RE: Revision 12 to Permit BNCR-9401

This submittal contains a response to your letter to us dated June 6, 2012. In this letter you listed technical deficiencies that must be addressed before the permit revision application for BNCR-9401 can be deemed complete. Below is a listing of the deficiencies followed by our response:

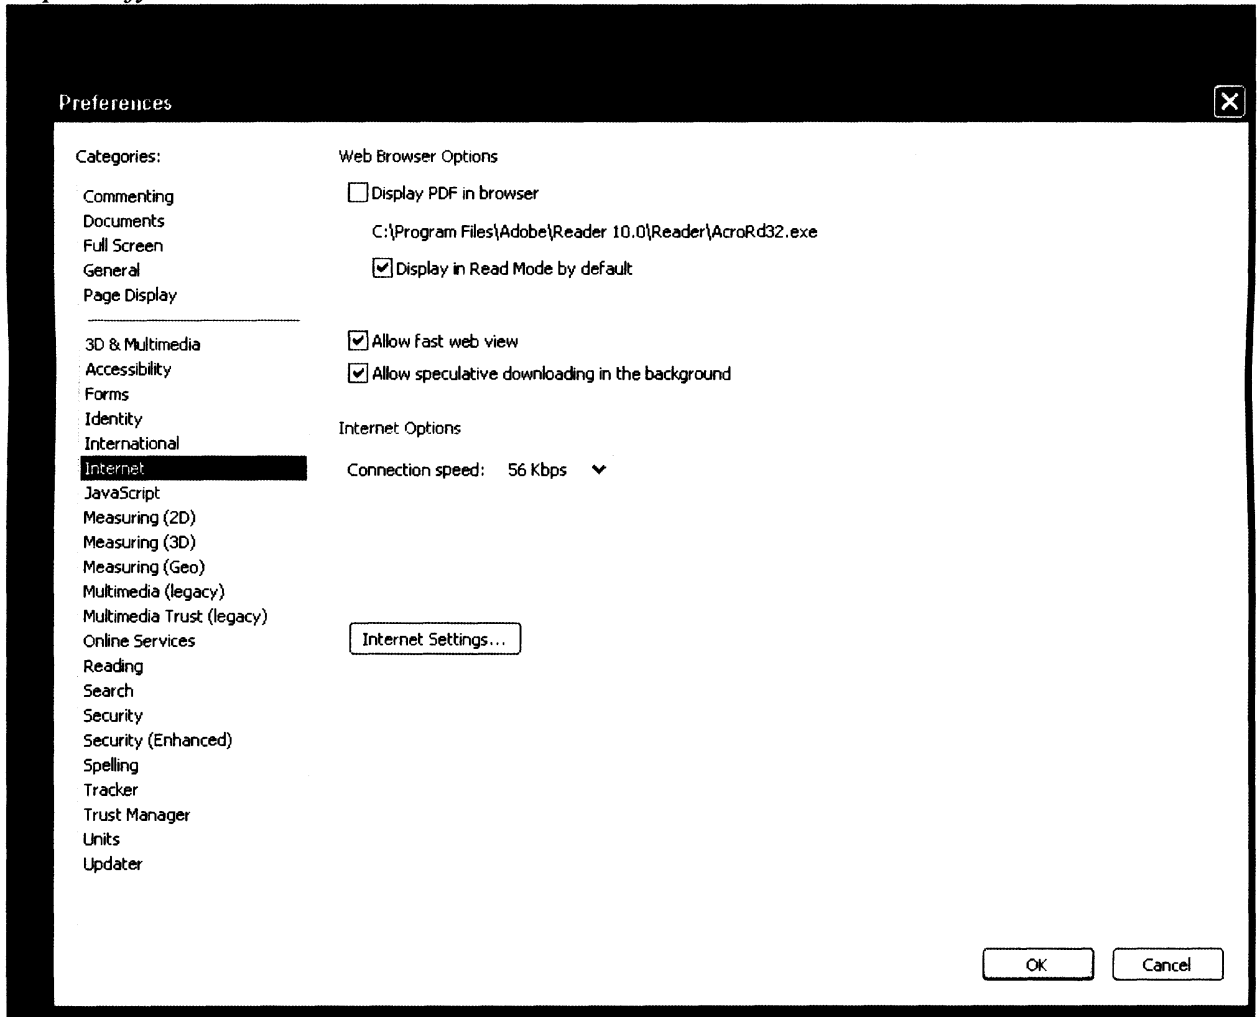
2. It does not appear that the hyperlinks in the Legal and Financial Information section are functional. Please repair the links so they are operable as intended. (GAW/BEB)

This same issue occurred in the electronic BNCR-9702 and seemed to be resolved when the following steps were taken with Adobe Reader and/or Acrobat Pro so that the links work properly. Open Adobe/Acrobat Pro software, click Edit, Preferences, under the Categories column on the left, click on Internet. At the top of the Internet tab UNCHECK the box by "Display PDF in Browser, click OK. The following is an illustration of the Internet tab to help clarify what it should look like.
